# CITY OF SACRAMENTO

- SUBJECT:
1. Subdivision Modification to waive service connections
  2. Tentative Map (P-9016)
  3. Appeal of the conditions of the Special Permit which require a reduction of parking ratio from 2.0 to 1.5 spaces per unit; shake or heavy composition shingles; and redesign of the site plan to allow for more north/south oriented units

LOCATION: Southeast corner of San Juan Road and Miramonte Drive

Del Verde Square  
 176 Units  
 Sacramento, California

EXHIBIT A-1

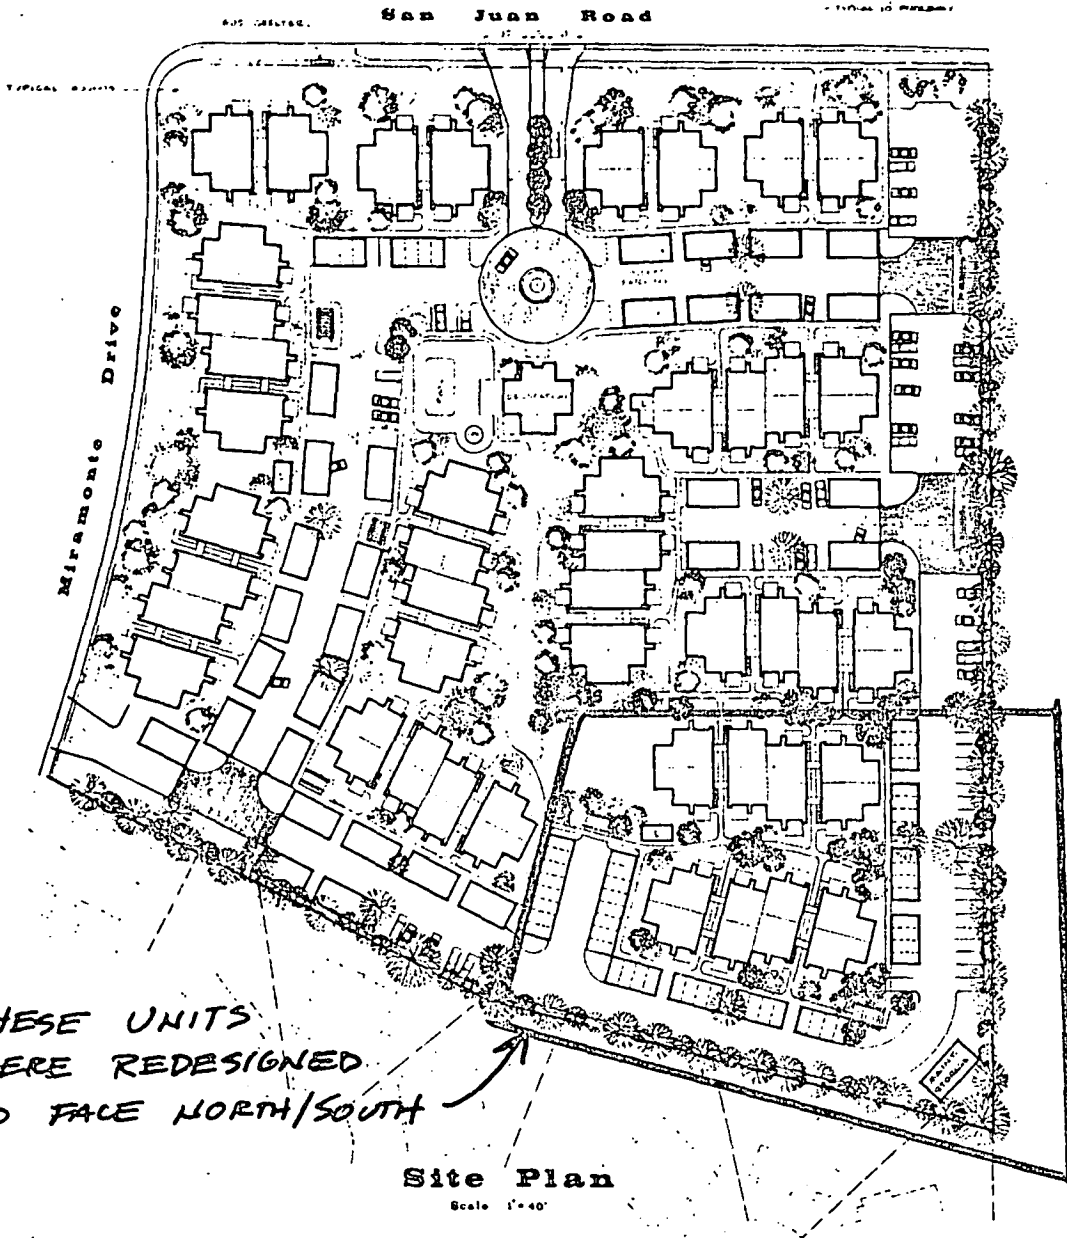
Subsequent to the meeting, the applicant redesigned the site plan in order to accommodate 64 percent north/south units. This was accomplished by redesigning 32 units located at the southeast corner of the site. The redesign is not consistent with staff's original recommendation which suggested a redesign of 32 units

located in the center of the site. However, staff has no objection to the revised site layout because it meets the original objective to accommodate a 64 percent north/south unit orientation. The staff therefore believes that condition "e" (page 3 of the City Planning Commission report) has been satisfied.

With reference to the first issue, the applicant's redesign provides a ratio of 1.77 parking spaces per unit. Staff believes that the reduction from 2.0 to 1.77 spaces per unit is satisfactory for this type of development.

1. Approval of the appeal to allow a 1.77 parking ratio and to allow the redesign of the units located at the southeast corner of the site as shown on Exhibit A-1.
2. Denial of the appeal to delete condition requiring shake or similar roof type.

EXHIBIT "D"

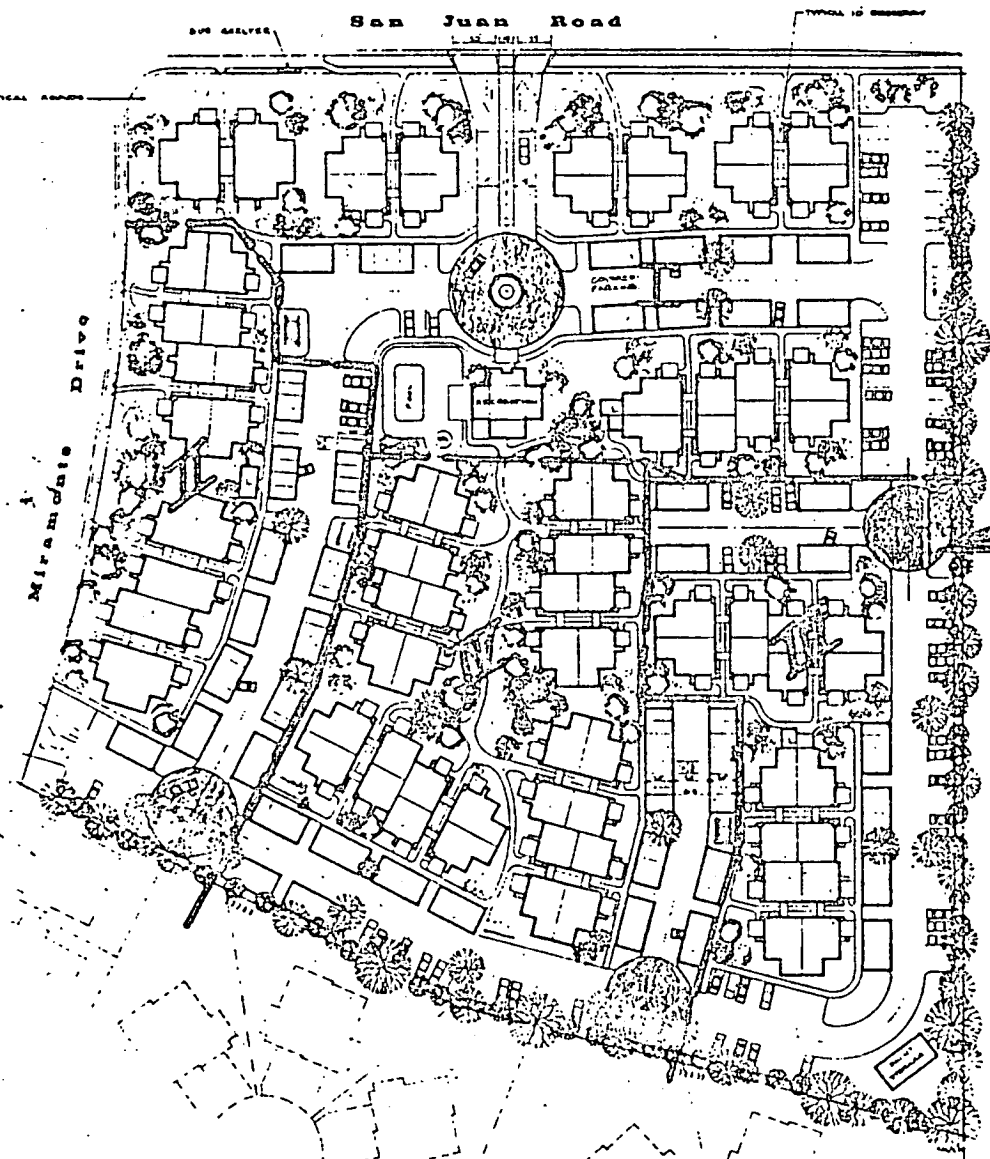
1. At the intersections of driveways within the project, a circular textured concrete has been used to reduce the speed of automobile traffic. This technique will help to reduce the speed of automobiles; however, staff believes they should be redesigned as per Exhibit D in order to provide additional landscaping between the project and adjacent residential and commercial uses and to provide more landscaping within the project.

3. In order to encourage the use of on-site parking, staff suggests that four pedestrian walkways be eliminated along Miramonte Drive. This is illustrated on Exhibit "D".

4. Staff would also suggest that additional landscaping be provided in the area as shown on Exhibit "D".
5. The project is designed with 80 units (45%) oriented in a north/south direction. Staff suggests that the 32 units as shown on Exhibit "D" be redesigned to orient in a north/south direction. This would increase the percentage of north/south units to 112 (64%).

CIRCULAR  
TEXTURED CONCRETE

- a. The textured concrete located within the driveways shall be redesigned as per Exhibit "D".
- b. A greater variation in setbacks shall be provided along San Juan Road.
- c. The four pedestrian walkways along Miramonte Drive shall be eliminated as per Exhibit "D".
- d. The end walls of the clustered units shall have window elements and the roofing materials shall consist of shake or a heavy imitation shake type material subject to the approval of the Planning Director.
- e. The 32 units as shown on Exhibit D Shall be redesigned to orient north/south in order to accommodate a greater percent of north/south units.
- f. Revised site plans and elevations in accordance with the above conditions and attached design criteria shall be submitted to staff for review and approval prior to issuance of building permits.

EXHIBIT "D"

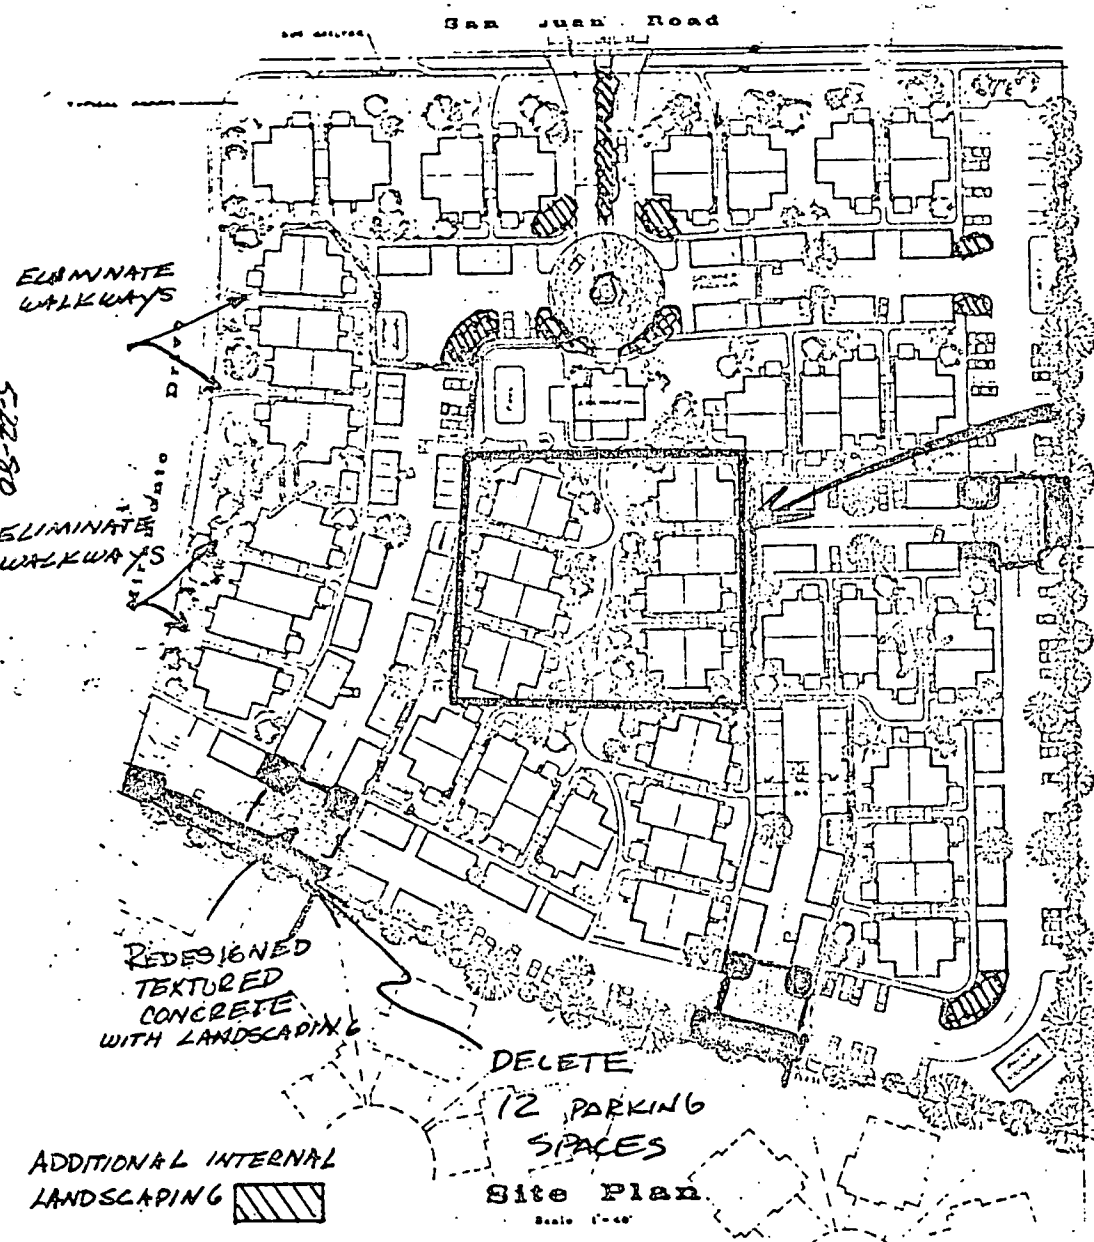
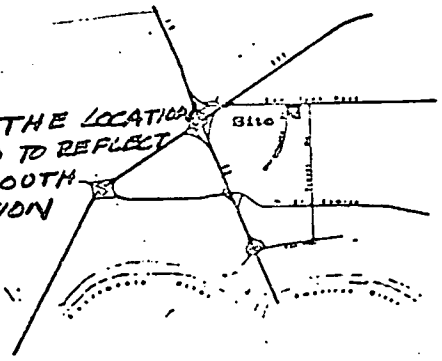
2. Condition "e" (pg. 3 of CPC report): "The 32 units as shown on Exhibit "D" shall be redesigned to orient north/south in order to accommodate a greater percent of north/south units."
3. Condition "h" (pg. 6 of CPC report): "The parking ratio shall be reduced to 1.5 and the eliminated parking shall be replaced with landscaping." This condition was added by the Planning Commission.

2. Condition "e": This condition was suggested because it would allow for more north/south oriented units. The project as proposed by the applicant consists of 80 units (45%) oriented in a north/south direction. The recommended condition would require 32 additional units be oriented north/south which would increase the percentage of N/S units to 64 percent (112 units). This condition is consistent with the South Natomas Community Plan which requires a minimum of 60 percent north/south units.

CHANGE THE LOCATION OF 32 UNITS TO REFLECT A NORTH-SOUTH ORIENTATION

EXHIBIT "E"

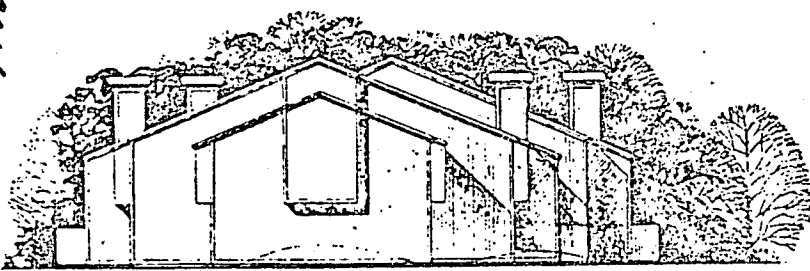
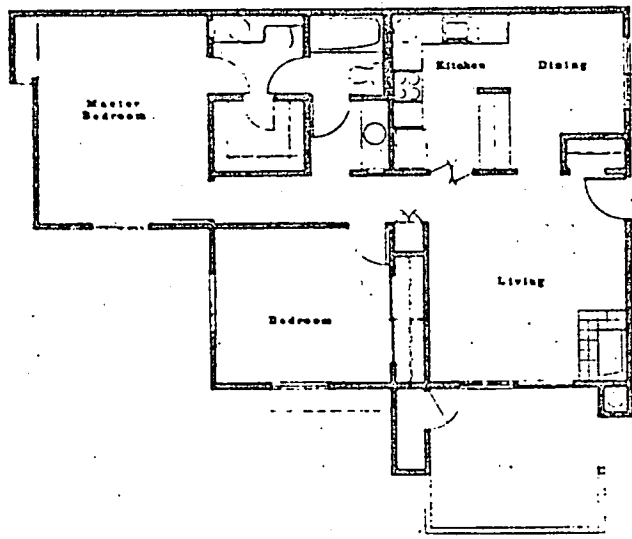
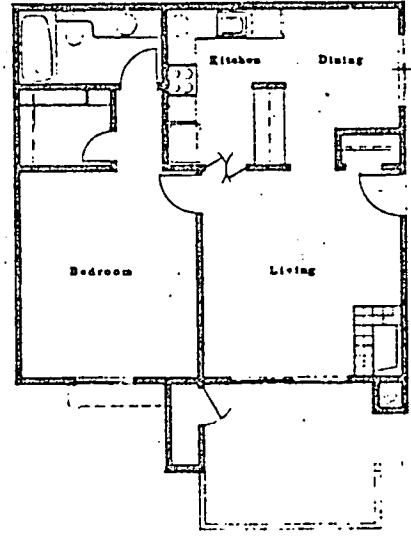
1. In order to visually break up the end walls of the cluster units (Exhibit E), windows should be provided. This additional element will improve the design of the units as viewed from the street and within the project.
2. The elevations do not indicate the roofing materials that will be utilized. Staff suggests that a shake or a heavy imitation shake type material be used.
